# MONITORING YEAR 4 ANNUAL REPORT

## HENRY FORK MITIGATION SITE

Catawba County, NC  
DEQ Contract No. 005782  
DMS Project No. 96306

RE: **Response to MY4 Draft Report Comments  
Henry Fork Mitigation Project**  
DMS Project # 96306  
Contract Number 005782  
RFP Number 16-005298  
Catawba River Basin – CU# 03050103 Expanded Service Area  
Catawba County, North Carolina

Figure 3.2 Integrated Current Condition Plan View (Sheet 2)  
 Henry Fork Mitigation Site  
 DMS Project No. 96306  
 Monitoring Year 4 - 2019

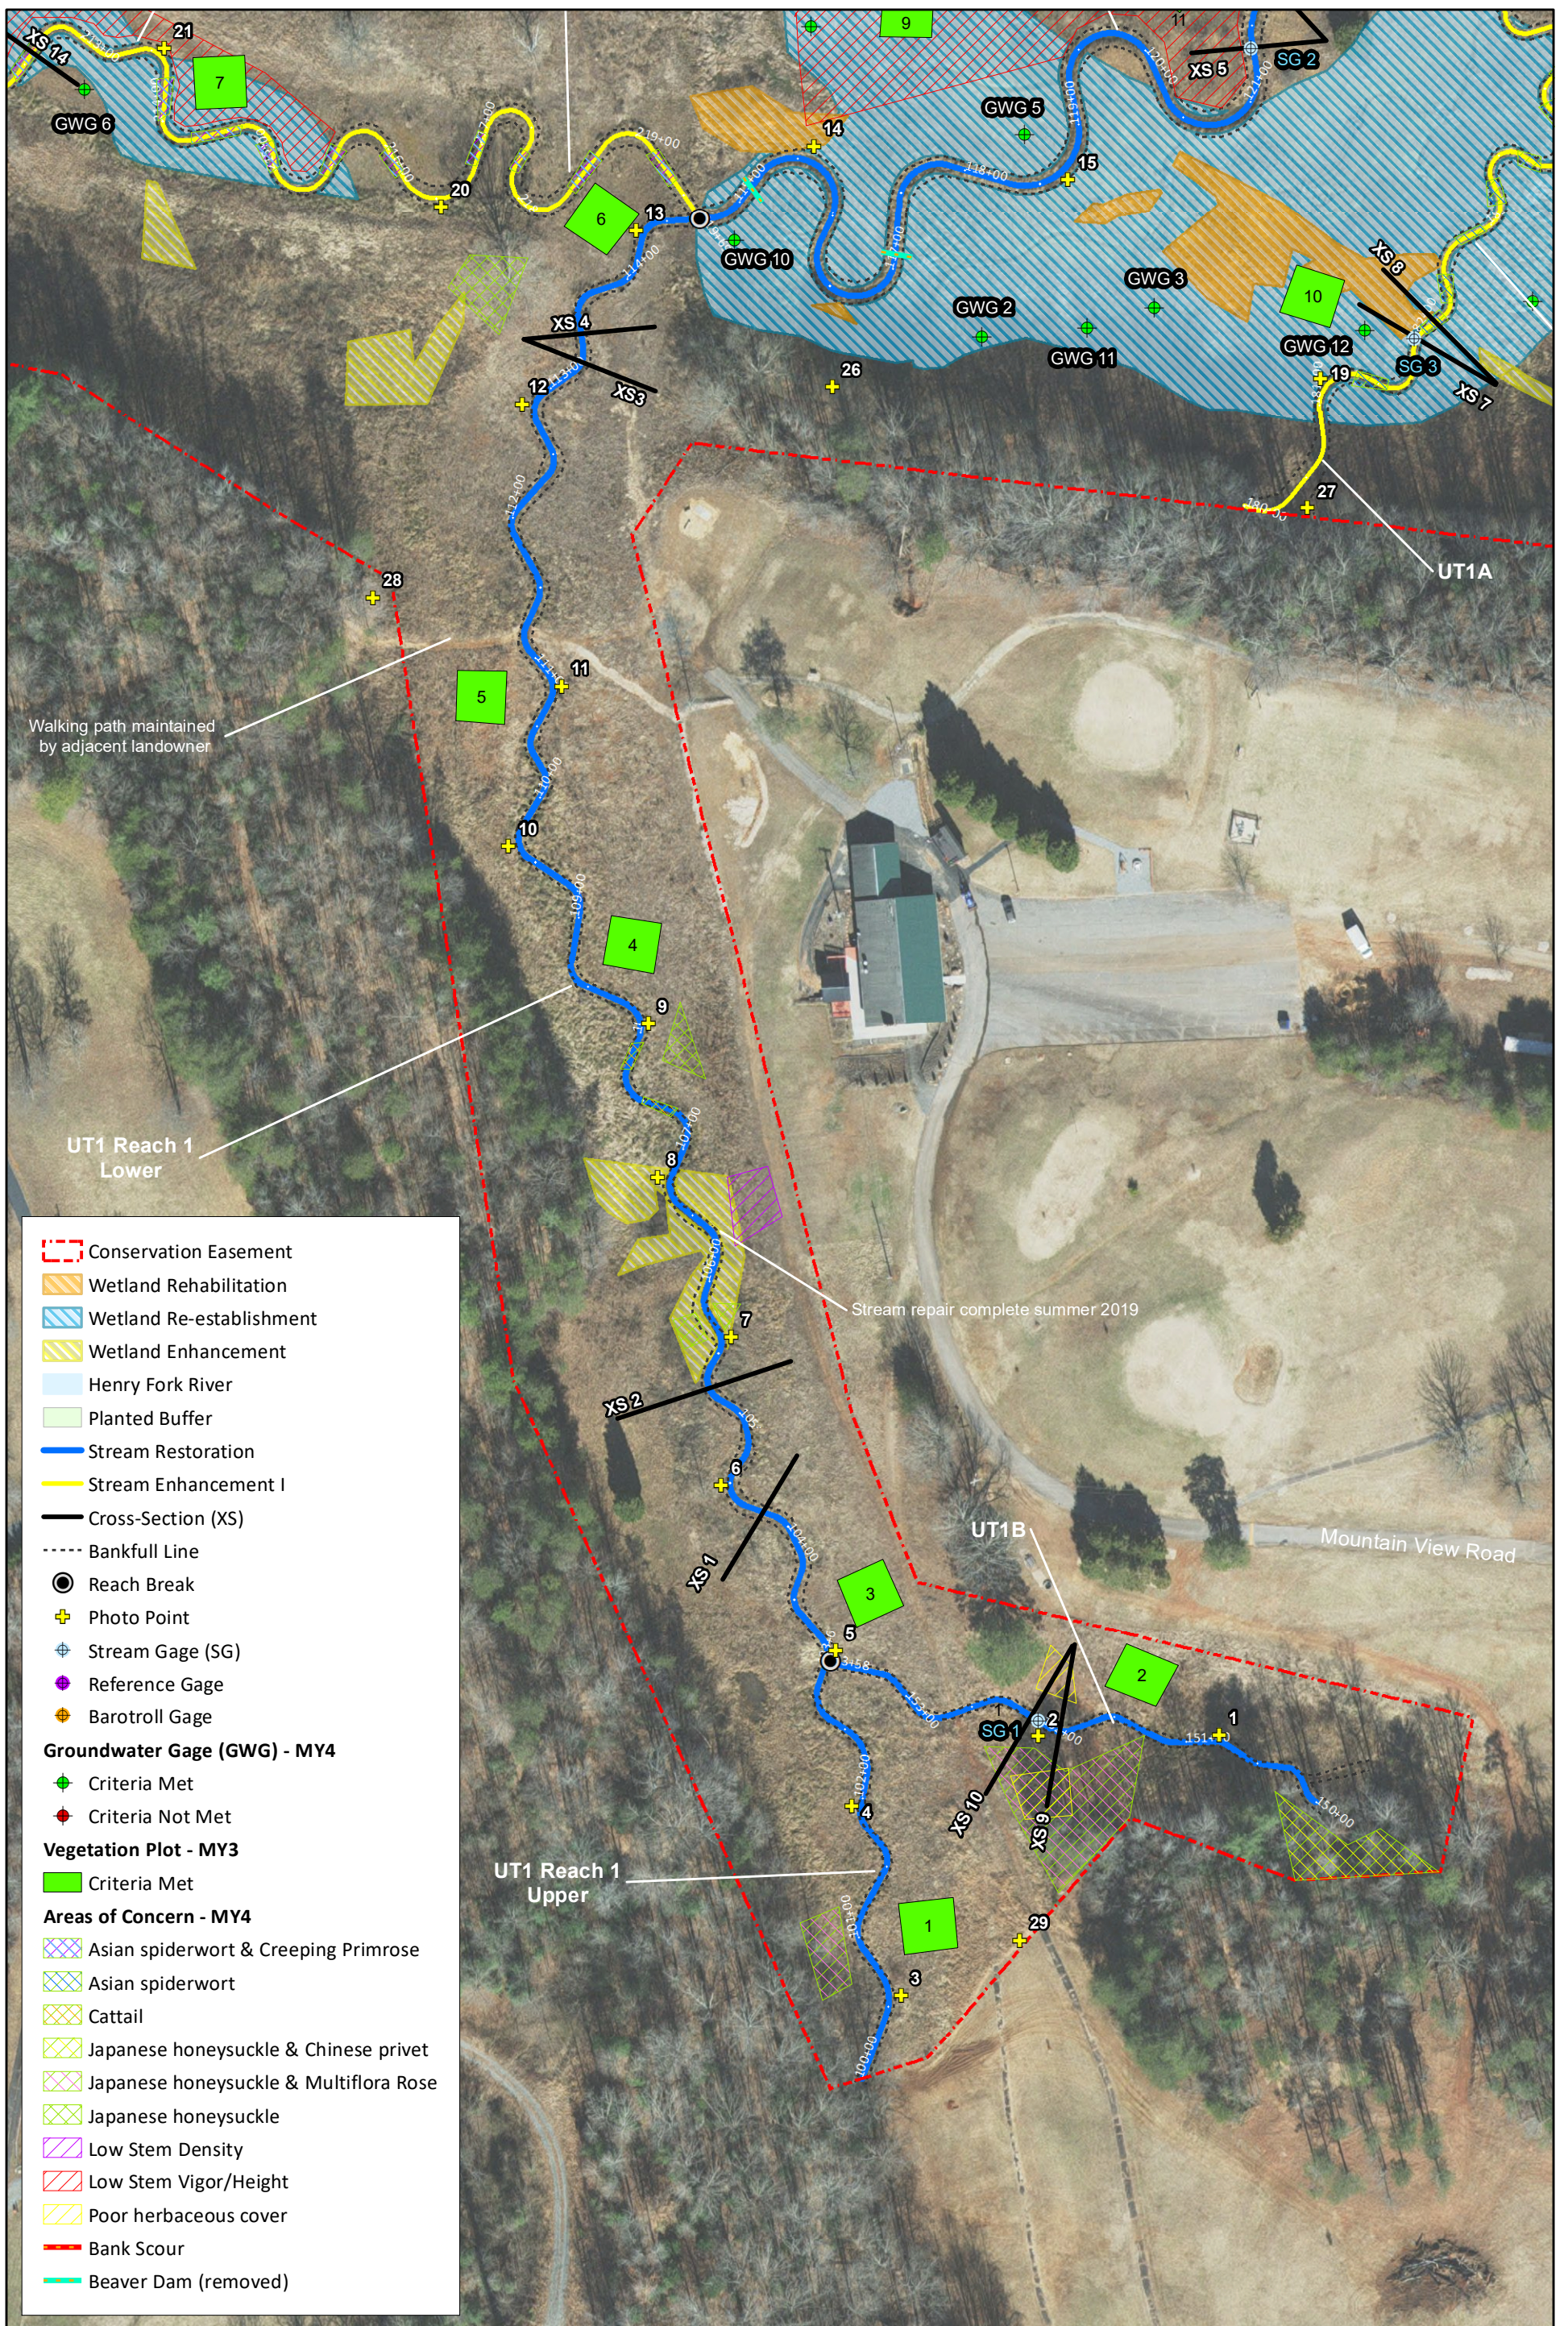
**DMS comment; Please add callout on CCPV for location of bank repair on UT1.**

*Wildlands response; A callout has been added to CCPV Figure 3.2 to note the location of the bank repair on UT1.*
